E8363BH85-07A

S E R V I C E N O T E

E8363BH85 PNA Series RF Network Analyzers

Add-on mechanical components to enhance instrument reliability

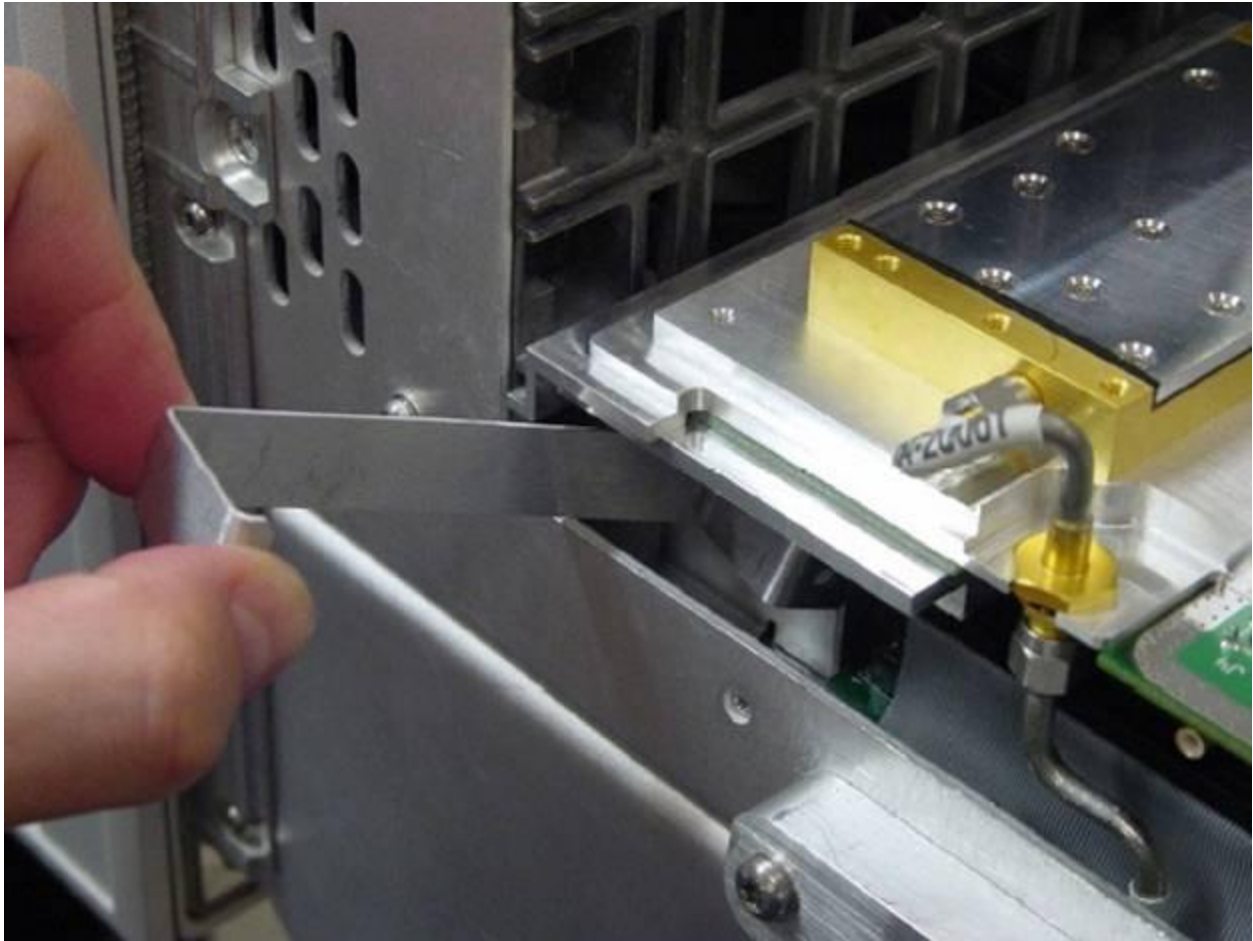
- a. Remove and discard existing screw near ribbon cable connector on System Motherboard. See below.

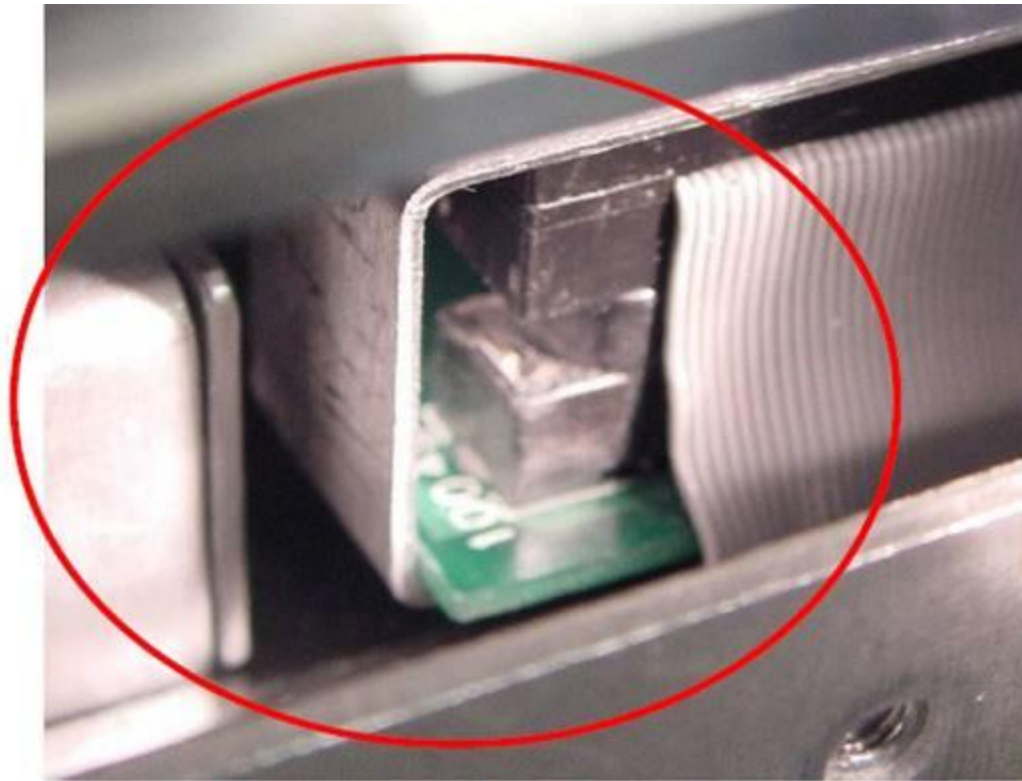
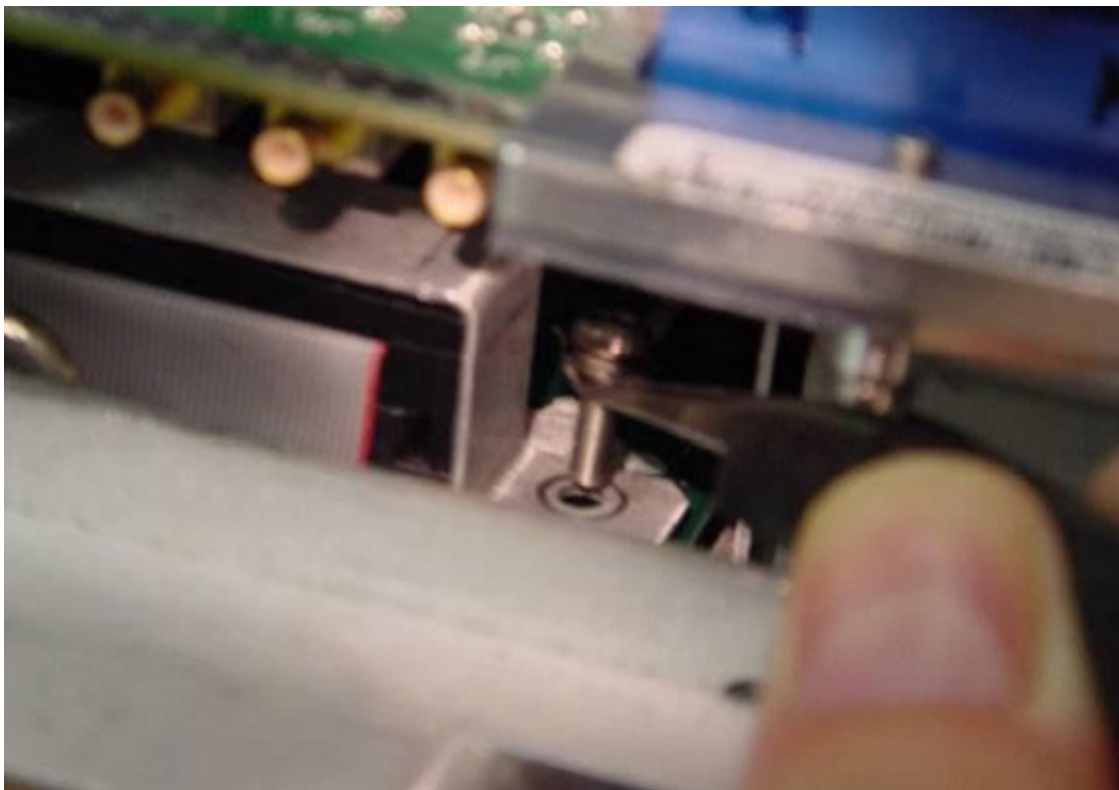
- b. Insert Ribbon Cable Clamp under Source Assembly as shown.

- c. Position the clamp over the Ribbon Connector. Use needle nose pliers if necessary to slide the clamp into place. Ensure that the edge of the clamp is parallel to the connector and not skewed.

NOTE: Ensure that the Clamp Lip is secured BELOW the edge of the System Motherboard

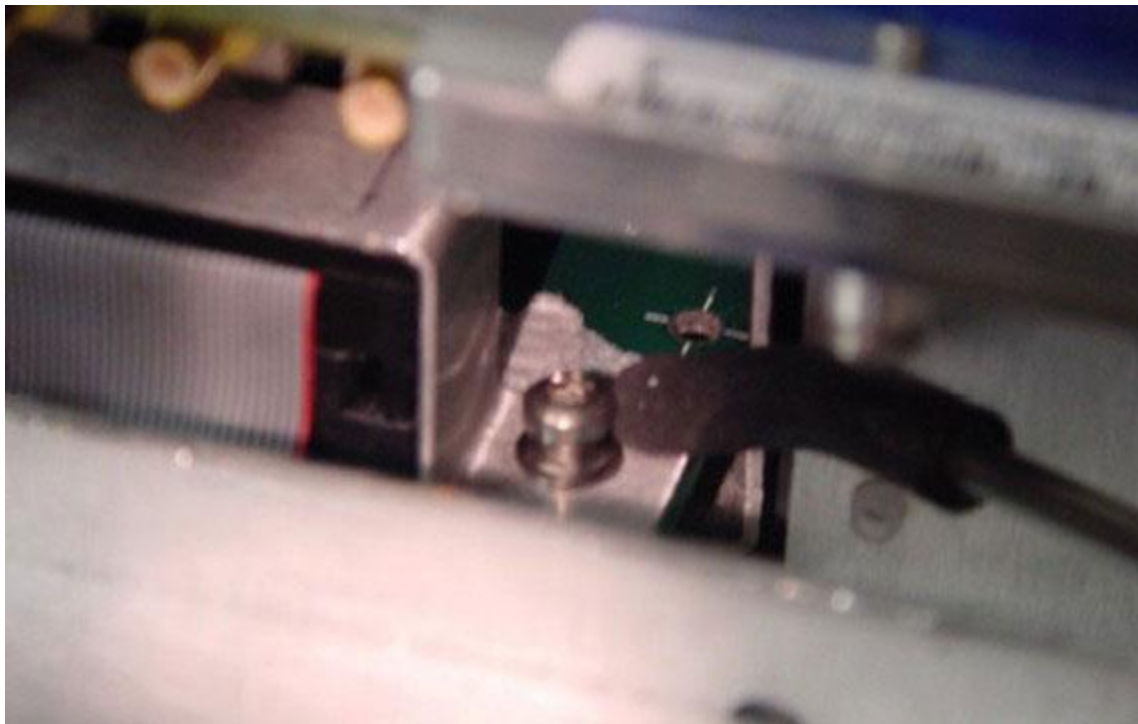
- d. Using tweezers, install a new 0515-0374 screw through the hole in the bracket.

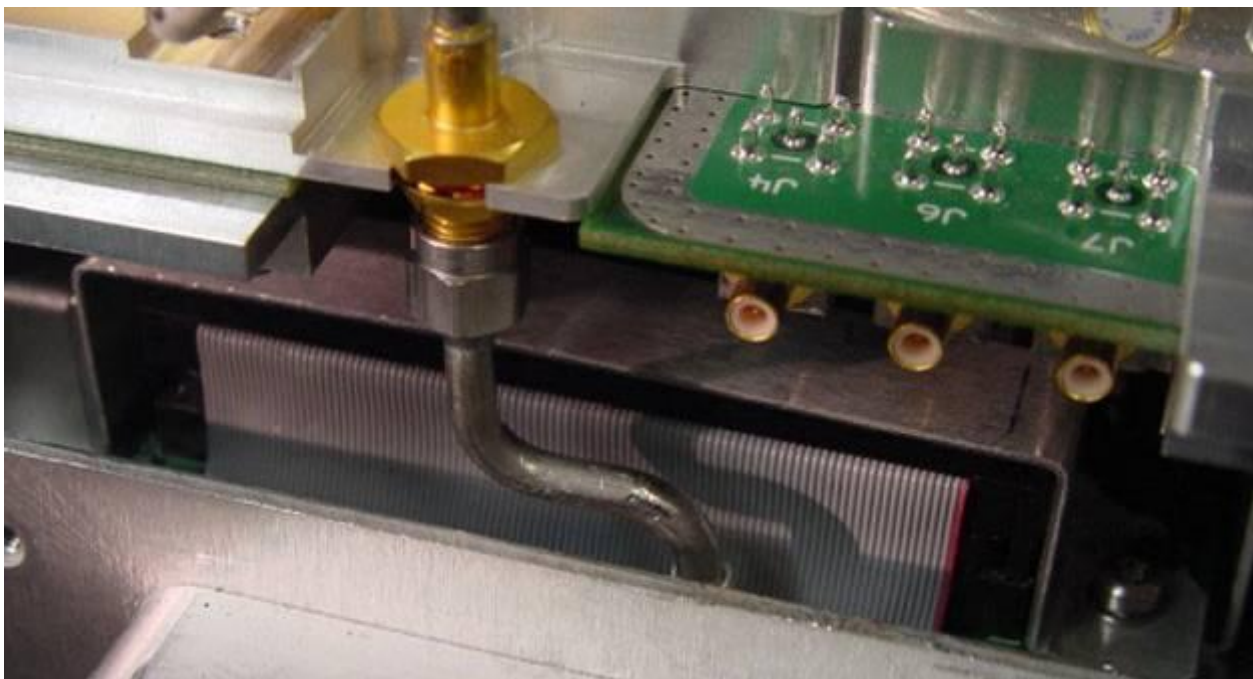
- e. Use a nut runner tool (T-316130) or alternatively a clean erasure end of a pencil to help run the screw.

- f. Secure screw using the modified 10 lb-in breakaway wrench.

g. This image shows the final position of the secured clamp.

Figure 2a

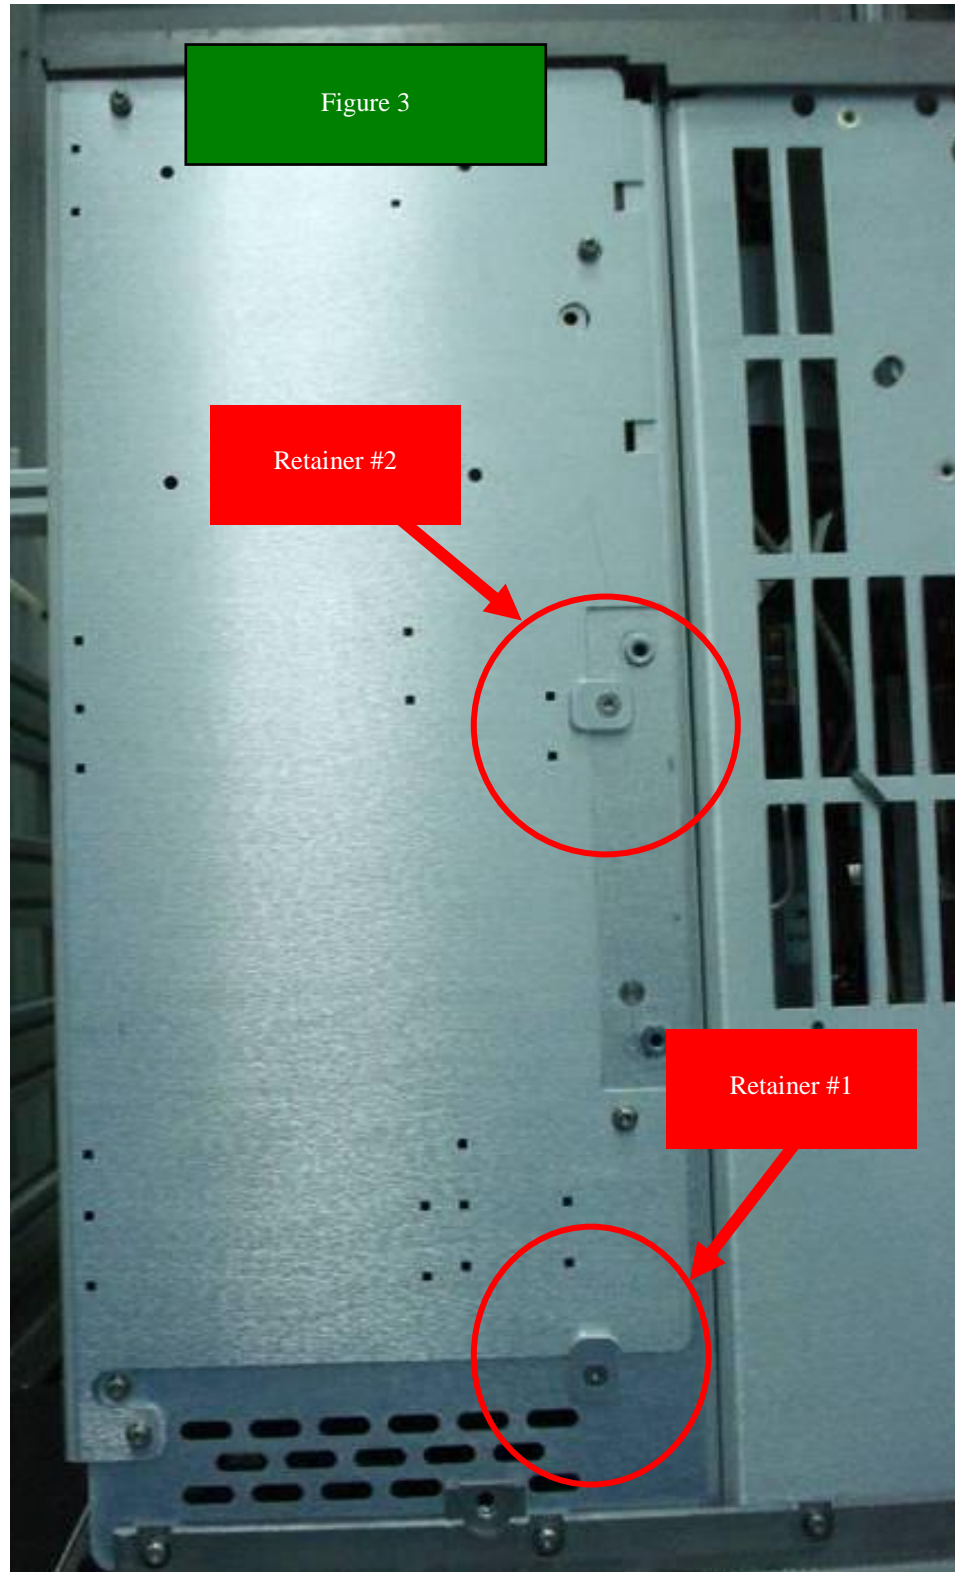
The Clip Retainer (E8361-20067) to be secured with Flat Head screw (0515-1644) in 2 places at 9 lb-in. This Retainer Clip may naturally rotate a bit when being secured, which is acceptable. Note that the existing screw needs to be removed and discarded prior installing Retainer Clip #1 (shown below in Figure 2a, 2b, and 3).
